Anowara Knit Composite Ltd. (New Building 9 Dyeing)

Mulayed, Maona, Sreepur, Gazipur
Co-ordinates: 24.228620, 90.407298
16th November 2020

Observations

Incomplete as-built drawings of external steel stair

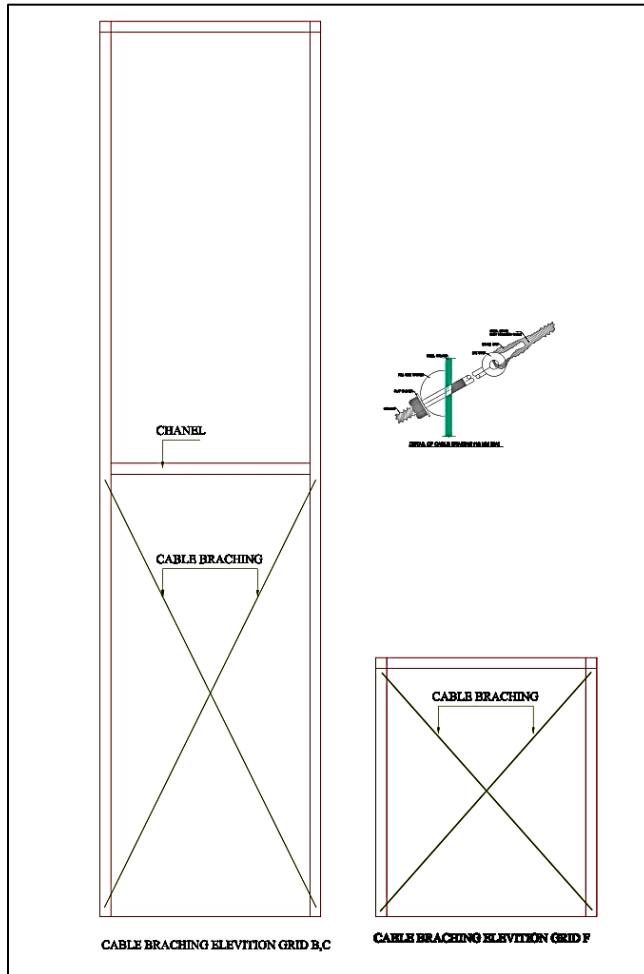
There is a steel stair adjacent to Building 10 (REB Building). Although as-built drawings for the stair was available but it lacks proper detailing of all the joints.

Corrosion in the steel stair columns

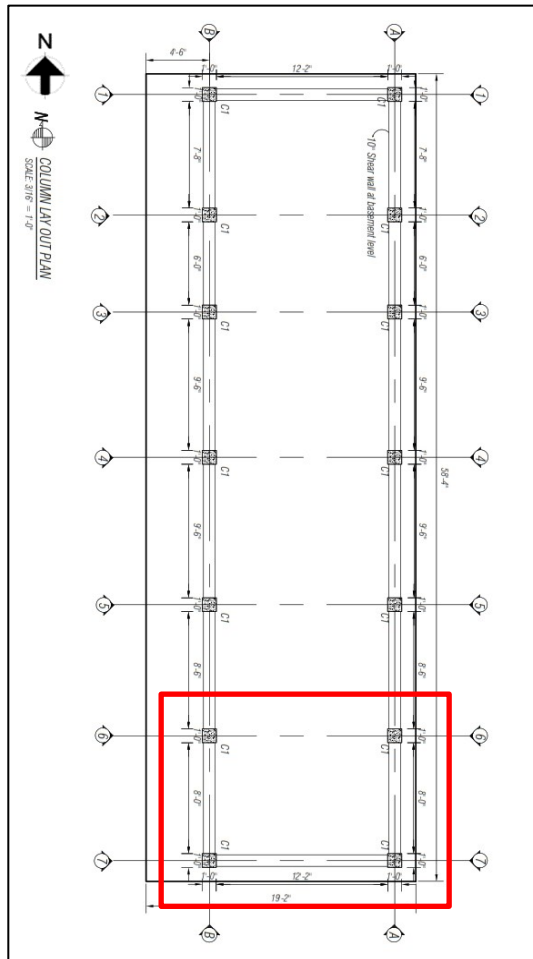
During inspection, corrosion in the steel stair columns was observed

Mismatches in As built drawings

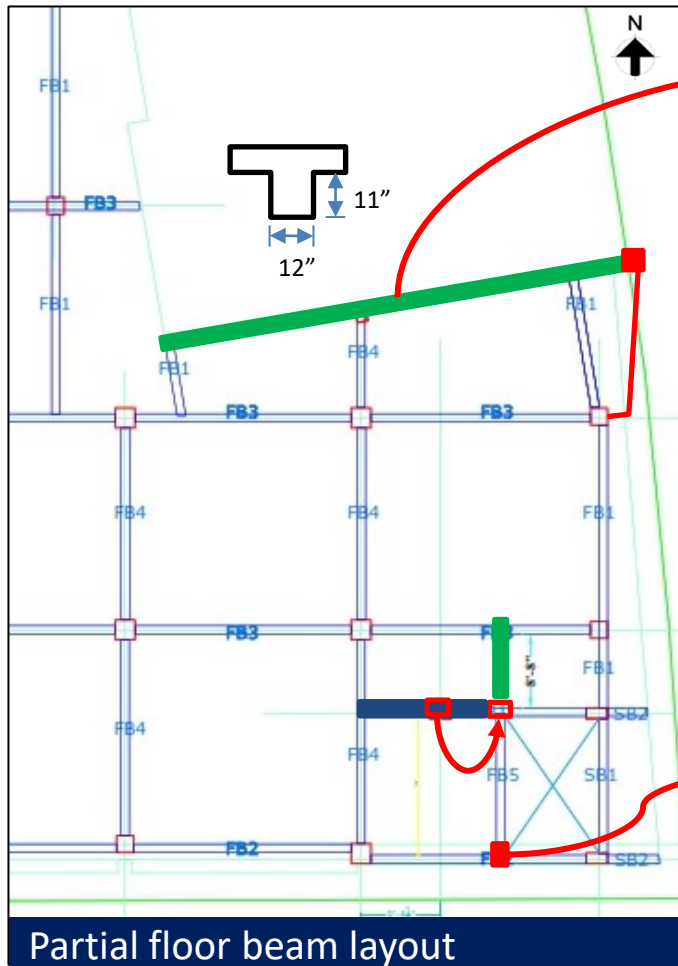
Building 11 (Lab Building) was found shorter in length along N-S direction. During inspection it was observed that span between gridline 6 and gridline 7 (marked in the layout) was not constructed.

Observation : Building 12 (Dyeing Extension-1)

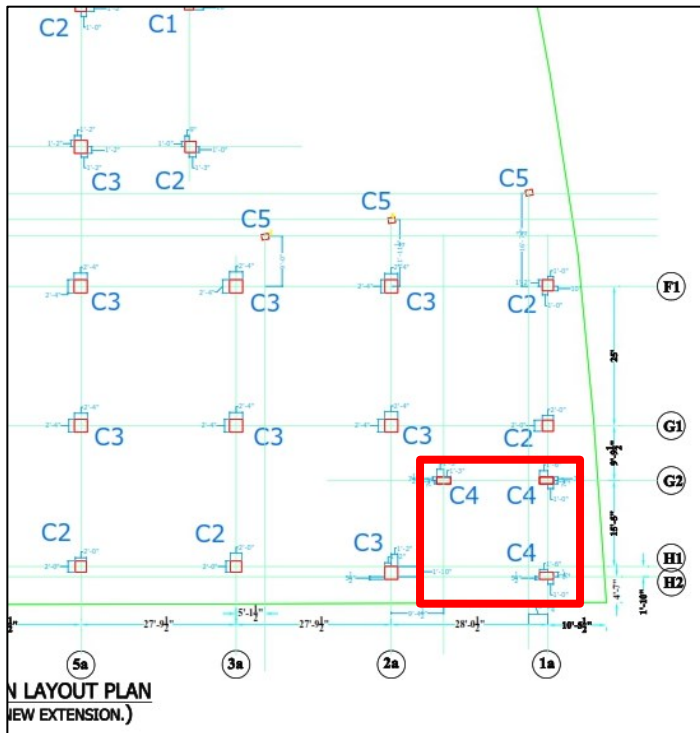
During inspection, two extra columns (marked red) were found which were not present in as built drawings. Also an undocumented beams (green marked) of size 12" x 11"(d/s) observed. Besides these a shift in column location found and beam in one location(marked blue) was not present. Above mentioned observations are shown in the floor beam layout plan.

High loading in Cantilever Area

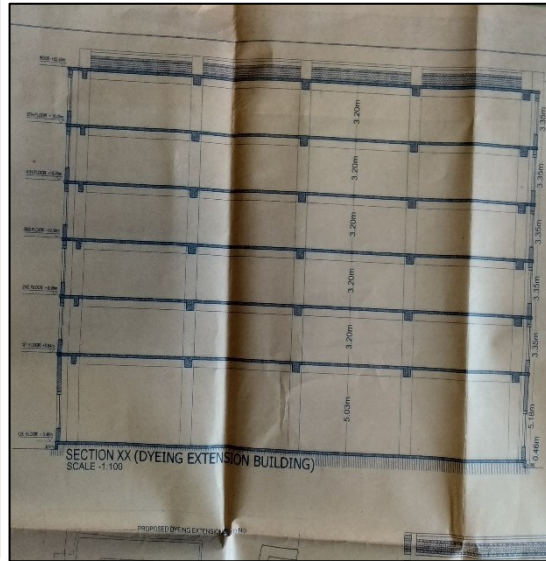
The cantilevered areas in the 2nd floor were heavily loaded and cracks were observed in the walls and column connection.

Item No.	Observation	Recommended Action Plan	Recommended Timeline
13	High loading in Cantilever Area. (Building 12 (Dyeing Extension-1))	Produce and maintain load plans for the cantilevered area considering assessment result.	6-weeks
14	Future Vertical Extension (All Buildings (Except Building 11 (Lab Building)))	In case of future vertical extension factory engineer is required to produce Detailed Engineering Assessment(DEA) of the structure/structures according to BNBC and submit to RSC for review.	6-weeks
15	Future Vertical Extension (All Buildings (Except Building 11 (Lab Building)))	Produce and actively manage loading plans for all floors considering floor, column and foundation capacity	6-weeks
16	Future Vertical Extension (All Buildings (Except Building 11 (Lab Building)))	Complete remedial works if arising from design report after reviewed by RSC.	6-months

Building 10 (REB Building)
(permission for 4 storied)

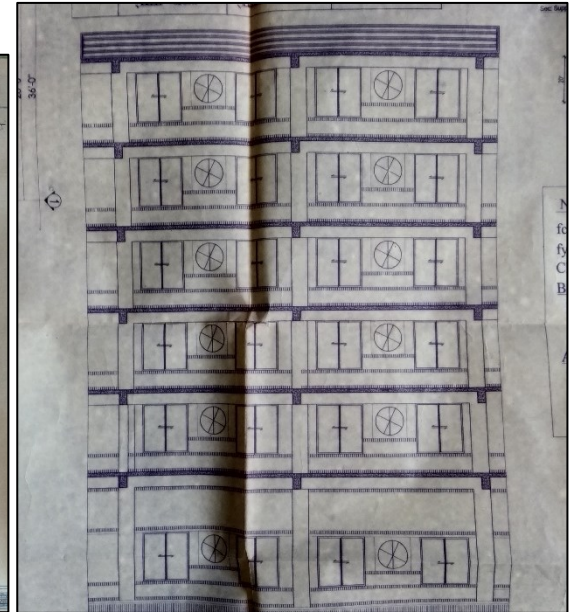
Building 10 (REB Building) permission application is for 4 storied structure, Building 12 (Dyeing Extension-1), Building 13 (Dyeing Extension-2) and Building 14 (Dyeing Extension-3) permission layout is for 6 storied structure. Till the date of this inspection, Building 10 (REB Building), Building 12 (Dyeing Extension-1), Building 14 (Dyeing Extension-3) were constructed upto three storeys and Building 13 (Dyeing Extension-2) was constructed upto two storeys. These buildings will be extended vertically in future.
